**Re: Nazareth Borough Municipal Authority Hower Farm Draft NPDES Permit for Discharges of Stormwater Associated with Construction Activities (PAD480199)**

**RE: Preliminary Review of Nazareth Borough Municipal Authority Hower Farm Draft NPDES Permit for Discharges of Stormwater Associated with Construction Activities (PAD480199)**

Meliora Design has reviewed the Draft NPDES Permit submission related to the Nazareth Borough Municipal Authority (NBMA) Hower Farm Project located at 6249 Hower Road in Plainfield Township, Northampton County, Pennsylvania, including the following documents prepared on behalf of the applicant:

Aerial Photograph of NBMA Hower Farm sourced from eMapPa

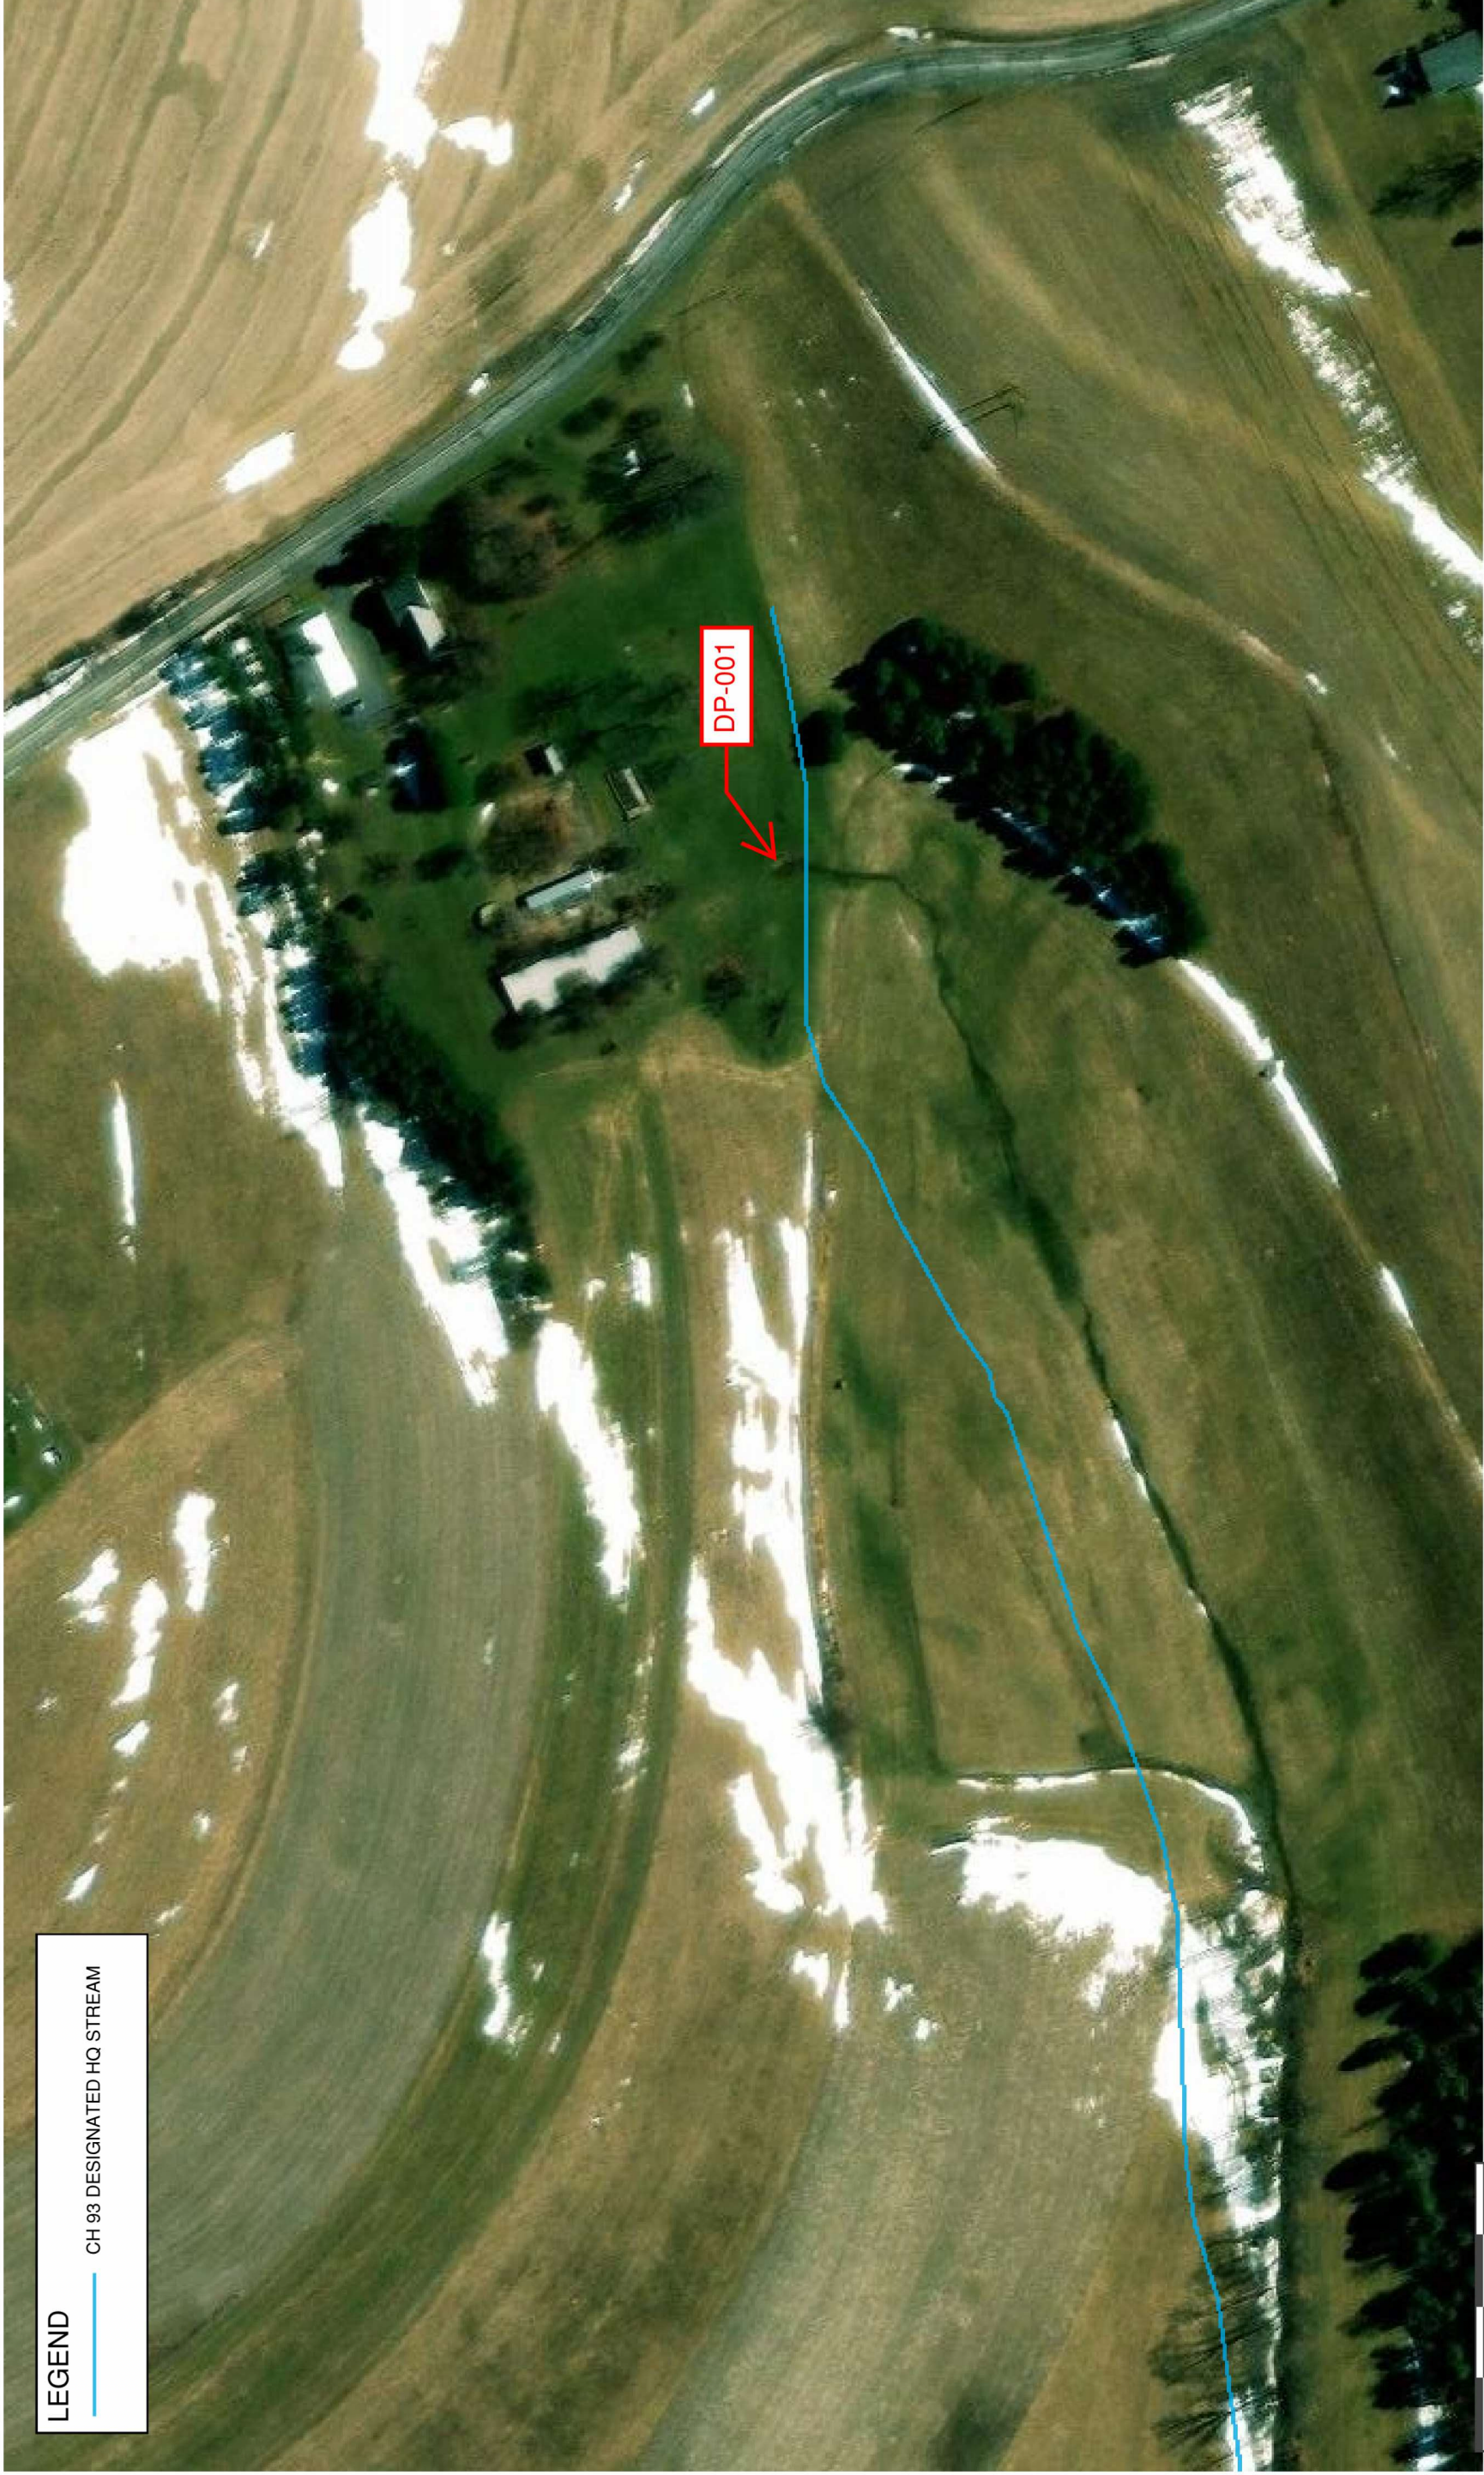
The wetland study performed by Bradley Gochnauer of Vortex Environmental on June 22, 2023 determined that the UNT to Little Bushkill originates where the applicant has shown on their drawings (approximately 500 ft from DP-001). We contest that it originates 0 ft from DP-001. It is important to note that this spring/summer was unusually dry, and this is an intermittent stream. It is likely that if the study were performed at a different time, the study would have been able to document the stream under flowing conditions. The investigation provided by Vortex Environmental seems insufficient to determine where the stream actually begins. The photos provided do not show a key map of where the photos were taken. From our interpretation, it looks like the photos were only taken in the forested area of the stream, with no photos provided near the project LOD where we suspect the stream begins. There is no proof offered that a stream does not exist upstream of the forested area. The Department should require more thorough documentation to support the extent of the stream channel.
